# Control of Air Pollution from New Motor Vehicles: Heavy-Duty Engine and Vehicle Standards

## Response to Comments

Assessment and Standards Division  
Office of Transportation and Air Quality  
U.S. Environmental Protection Agency

**Figure 3**  
**Modeled Ozone Season NO<sub>x</sub> Emissions in the OTR for Calendar Year 2023**

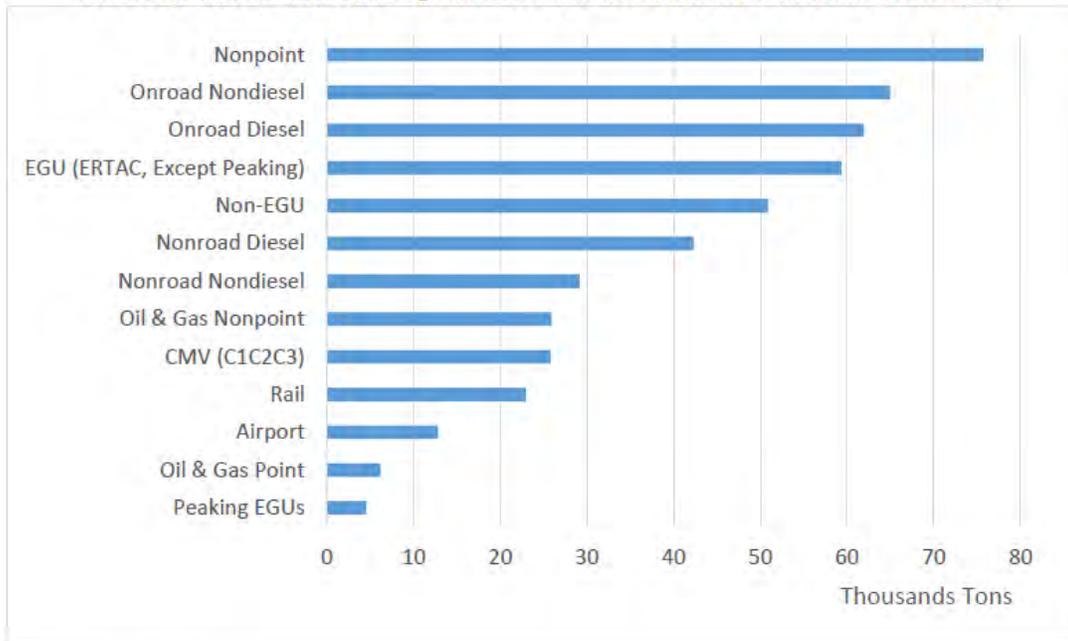
Regionally, heavy-duty vehicles are the third largest source of NO<sub>x</sub> emissions as illustrated in Figure 3. Moreover, the modeled NO<sub>x</sub> contribution from HDVs shown in Figure 3 is potentially underestimated, because the mobile source model used in developing the inventory does not account for high emitting heavy-duty trucks, such as glider vehicles and HDVs with tampered emission control systems. [EPA-HQ-OAR-2019-0055-1288-A1, p.4]

Figure 4: Modeled NOx Emissions in the Northeast (calendar year 2023).

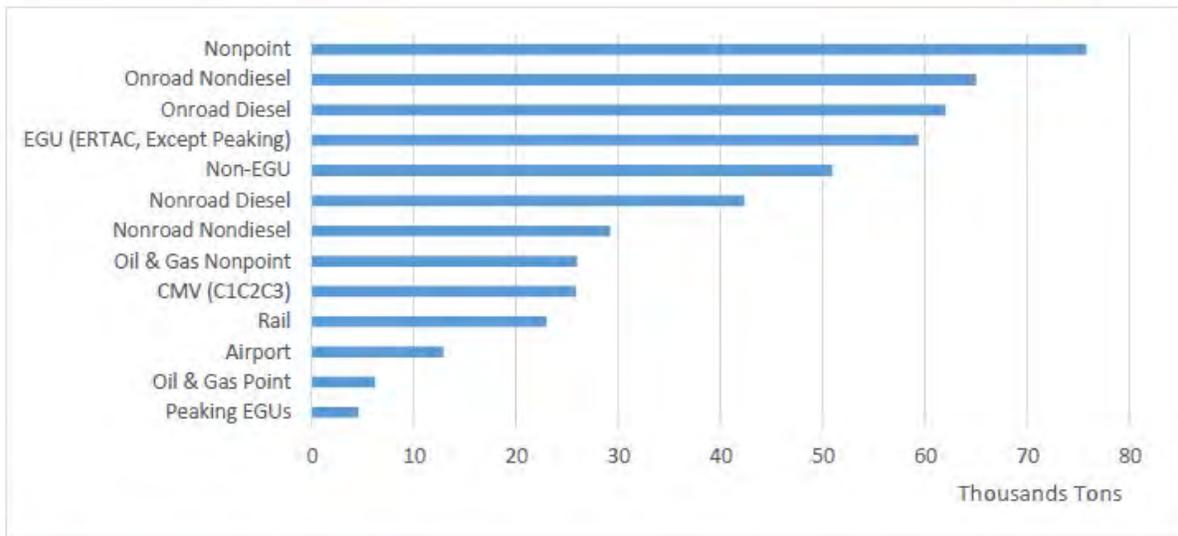
The modeled NO<sub>x</sub> contribution from HDVs shown in Figure 4 is potentially underestimated because the mobile source model used in developing the inventory does not account for high emitting heavy-duty trucks, such as glider vehicles and HDVs with tampered emission control systems. In-use testing data suggest that real-world NO<sub>x</sub> emissions are higher than modeled estimates, underscoring the need to achieve substantial NO<sub>x</sub> reductions from the heavy-duty diesel truck sector.<sup>16</sup> [EPA-HQ-OAR-2019-0055-1249-A1, p. 7]

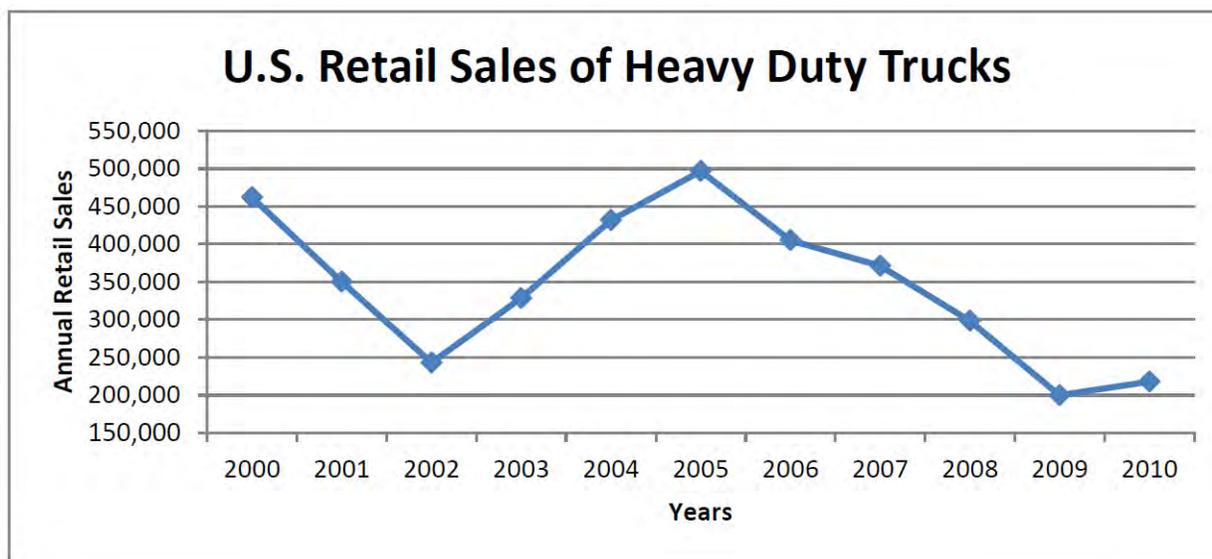
Figure 1 below, which graphs annual retail Class 4-8 CMV sales between 2000 and 2010, shows how prospective new truck purchasers rushed to "pre-buy" trucks equipped with pre-compliant technologies to avoid the cost and performance impacts of EPA's NOx mandates. A surge of orders began in 2002 for the pre-MY 2004 equipment, after which orders slumped significantly. In 2006, orders surged for pre-MY 2007 equipment, and then fell off precipitously. Lastly, in the 2009 timeframe, orders increased for pre-MY 2010 equipped trucks. In each instance, the new CMV marketplace recognized, anticipated, and sought to avoid the higher prices and poorer performance of the phased-in NOx mandate-compliant equipment. [EPA-HQ-OAR-2019-0055-1321-A1, p. 5]
